Grand Island Resources Cross Mine (M1977-410) Amendment #2 Response to DRMS Comments to Adequacy Review No.4

Issue Date:
February 3, 2022

GIR 110(2) Amendment 2 – Revision 2.0
Grand Island Resources, LLC. Responses to DRMS Adequacy Review No. 4, dated January 25, 2022
February 3, 2002

EXHIBIT E: CROSS AND CARIBOU MINES MINING PLAN MAP PROPOSED INTERNAL ROAD

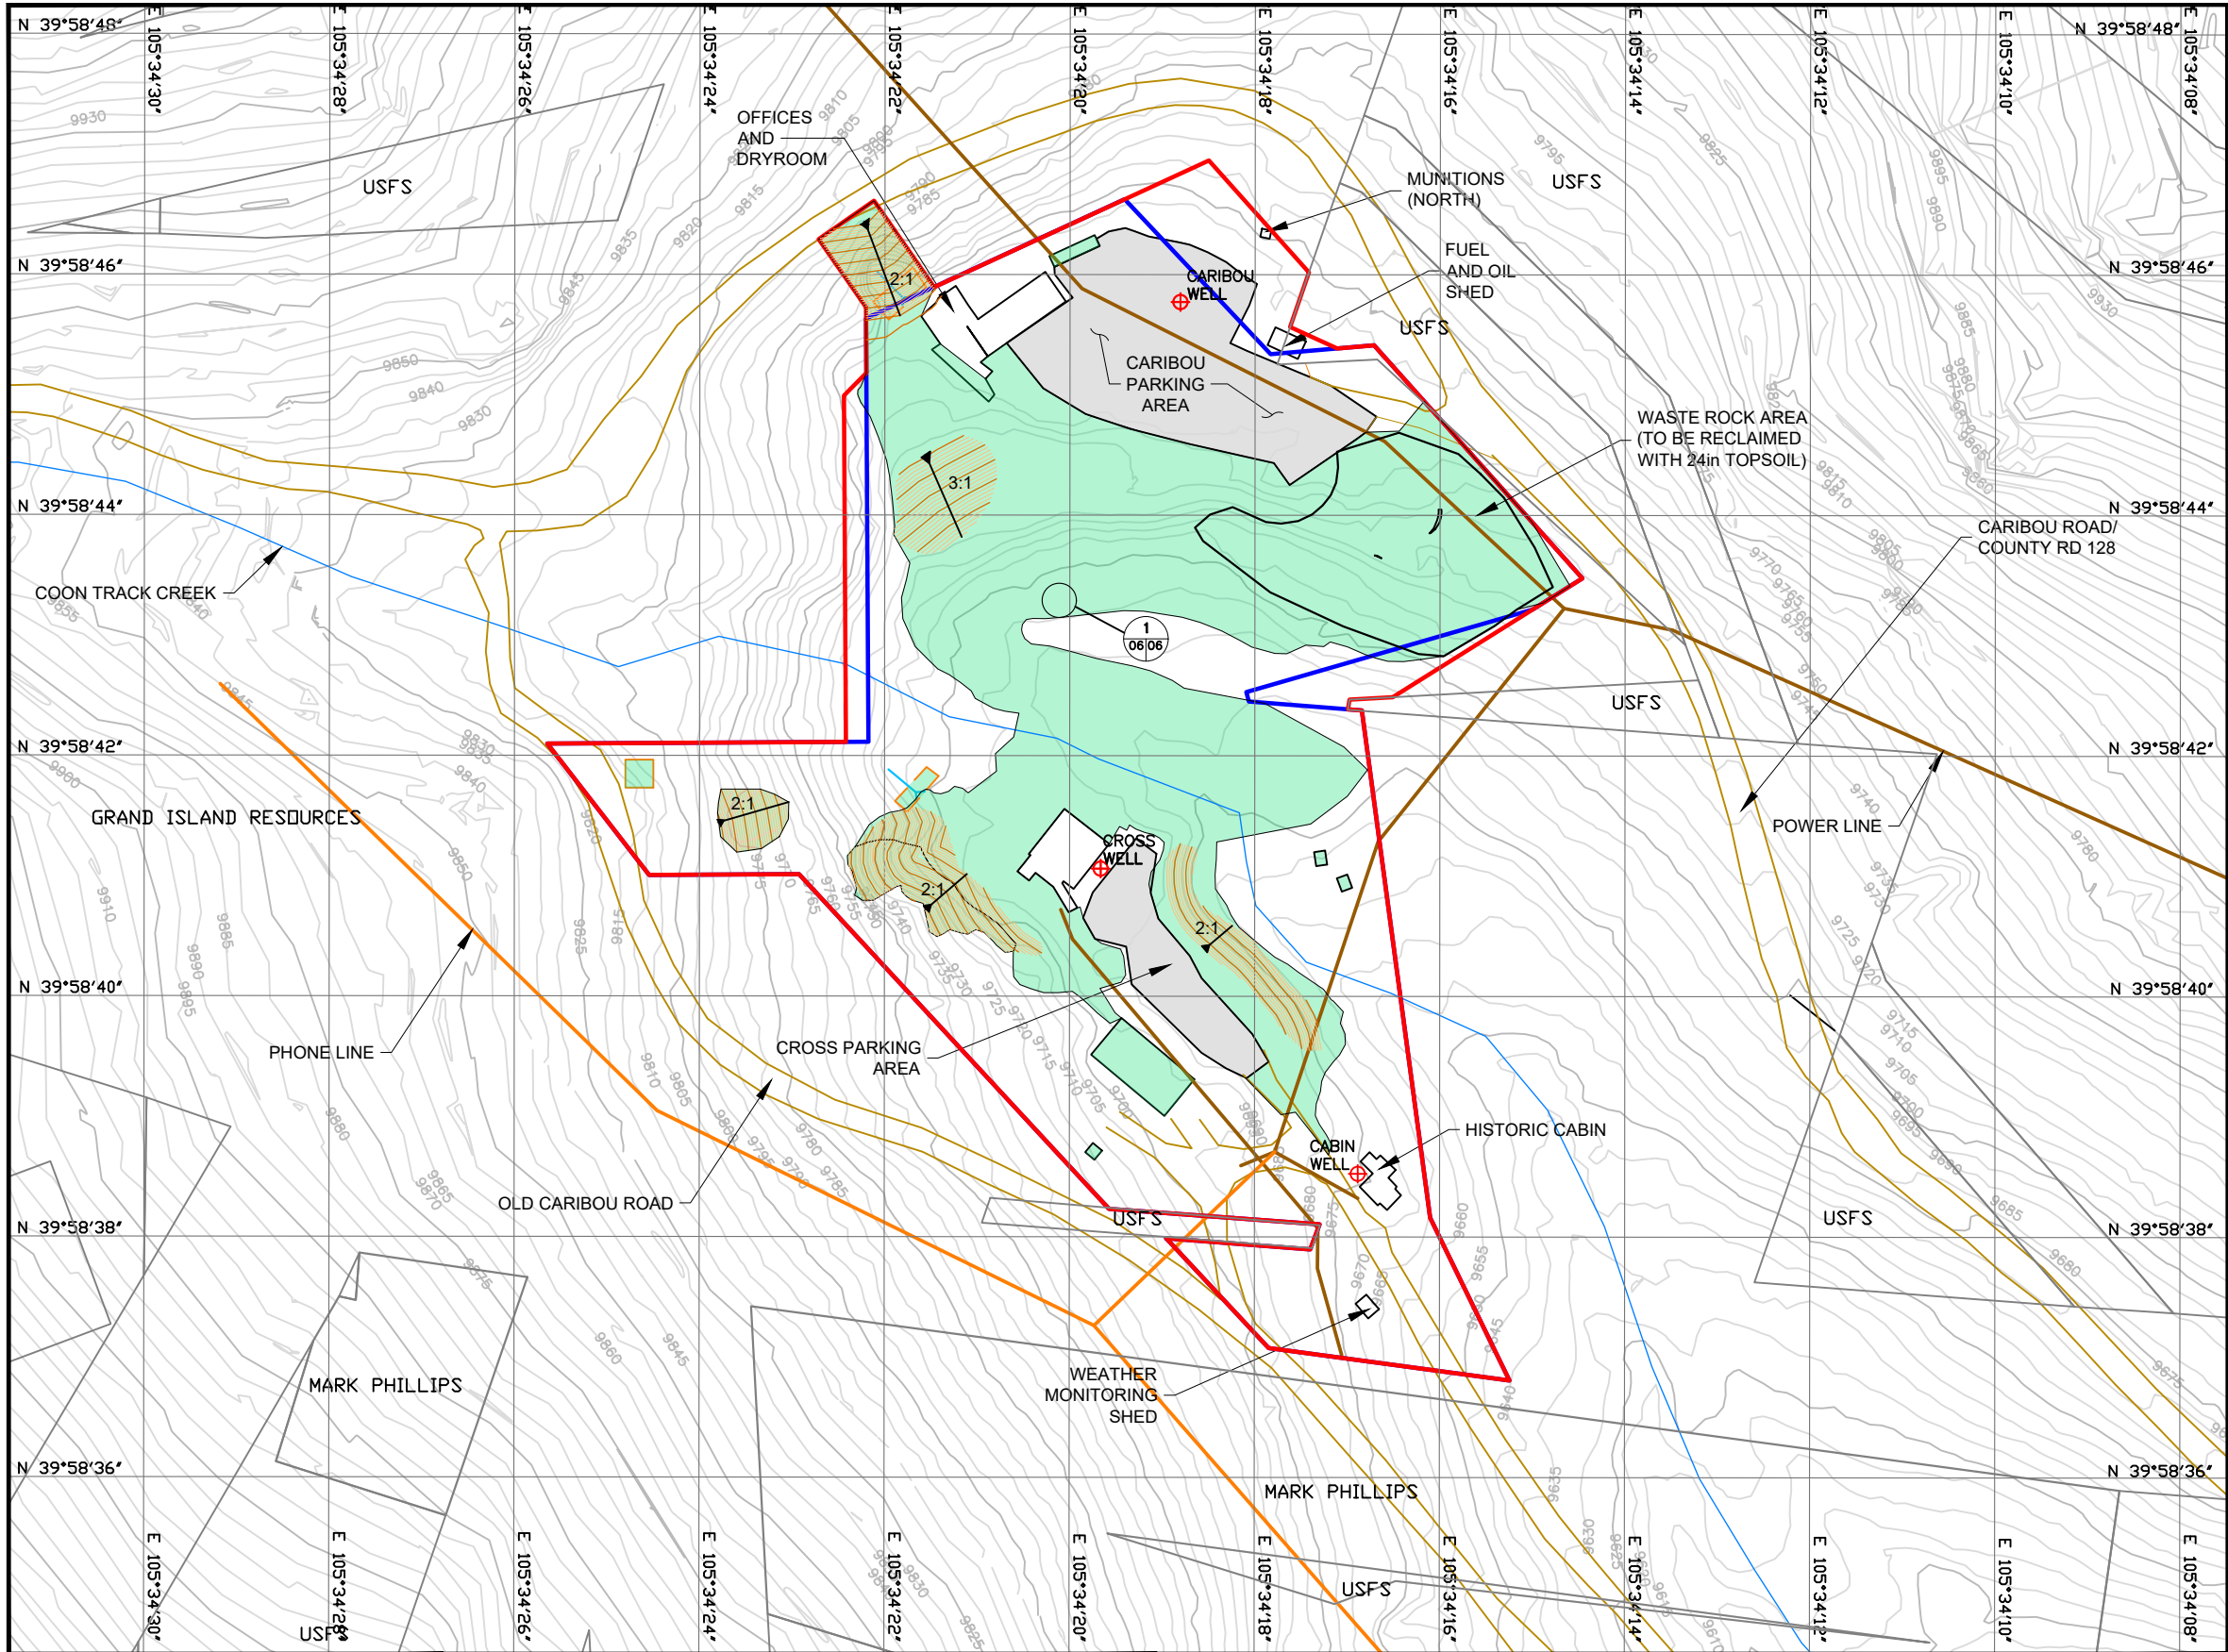
For Map 4, the Division has the following comments:

- a. Please show the approximate location(s) of any proposed topsoil stockpiles (one was proposed in the operator's Item #17 response).
- b. Please explain why the Cross Ventilation Shaft was removed from this map. This shaft was included on previously approved site maps.

a. The topsoil that will be removed from the footprint of the Internal Road will be bermed at the eastern toe of the road as the road travels through the northwestern section of the wetlands. The berm holding the topsoil will be seeded with the appropriate mountain blend so that the topsoil remains in good condition for future reclamation. The topsoil is now shown on Exhibit E, Map 4.

b. The Cross ventilation shaft was removed from site maps because the Cross ventilation shaft indicated on Maps 1, 3, 5, and 7, in GIR's submittal dated November 23, 2021 might have been placed on previous references and maps for proposal purposes. This ventilation shaft, dating back to in Amendment 1 may have been associated with the previously proposed Cross Decline (which was not built). Upon review of the maps and physical surface site inspections of the area and underground location of ventilation systems, we are confident there are no ventilation shafts at that location. This feature has caused confusion because nearby, to the north-west, is a depression from the historic Cross shaft that was filled in back in 1930s. This historic shaft has no access to the mine nor any ability to ventilate the mine. We are labeling this depression as a historical shaft depression.

EXHIBIT E - CROSS AND CARIBOU MINES RECLAMATION PLAN MAP CROSS/CARIBOU

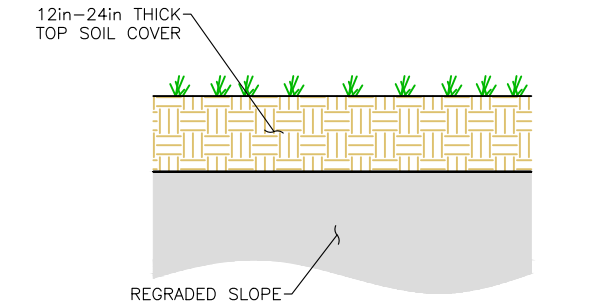
For (renumbered) Map 5, the Division has the following comments:

- a. This map shows the following structures to remain for reclamation: Caribou Offices and Dryroom, Caribou Well, Munitions (North), Fuel and Oil Shed, Caribou Parking Area, Cross Shop, Cross Well, Cross Parking Area, Historic Cabin, Cabin Well, and Weather Monitoring Shed. All other existing structures/features will be reclaimed. Is this accurate? The Division is asking for clarification as some structures are removed from this map, some are shaded light green (reclaimed and revegetated per the legend), and some are shaded dark green (no explanation provided in the legend). Please ensure all structures/features proposed to remain on this map correlates with the revised list requested in Item #3 above.

b. Please explain why the Cross Ventilation Shaft was removed from this map. This shaft was included on previously approved site maps. This disturbance area (observed during site inspections) will require reclamation, and therefore, reclamation of this area should be included in the reclamation plan and map(s).

- Please call this area “Historic Shaft Disturbance” and add it to maps 5 and 8.

a. The structures that will remain for reclamation are the Caribou Parking Area, Cross Parking Area, Subsurface Drinking Water Supply Line, Offices and Dryroom, Historic Cabin, Weather Monitoring Shed, Fuel and Oil Shed, Septic Tank and Leach Field, Potable Water Pipe, Sanitary Water, Pipe Caribou Management Office, Cross Shop, Munitions (North), Caribou Well, Cross Well and Cabin Well, and Existing Access Road. GIR revised the shading in the map so that all reclaimed and revegetated areas are shaded light green as per the legend.

b. The Cross ventilation shaft was removed from site maps because the Cross ventilation shaft indicated on Maps 1, 3, 5, and 7, in GIR's submittal dated November 23, 2021 might have been placed on previous references and maps for proposal purposes. This ventilation shaft, dating back to in Amendment 1 may have been associated with the previously proposed Cross Decline (which was not built). Upon review of the maps and physical surface site inspections of the area and underground location of ventilation systems, we are confident there are no ventilation shafts at that location. This feature has caused confusion because nearby, to the north-west, is a depression from the historic Cross shaft that was filled in back in 1930s. This historic shaft has no access to the mine nor any ability to ventilate the mine. We are labeling this depression as a historical shaft depression.

GRI Response: *The Cross Ventilation Shaft was renamed as the “Historic Shaft Disturbance” in Exhibit D, Section 1.2.6 and was added to Maps 5 and 8 (please see attached Maps).*

The historic shaft disturbance, shown in Exhibit E, Maps 5 and 8, will be reclaimed using waste rock. The depression in this area will be regraded to 2:1, re-vegetated using local topsoil, and covered with a sub-alpine seed mix.
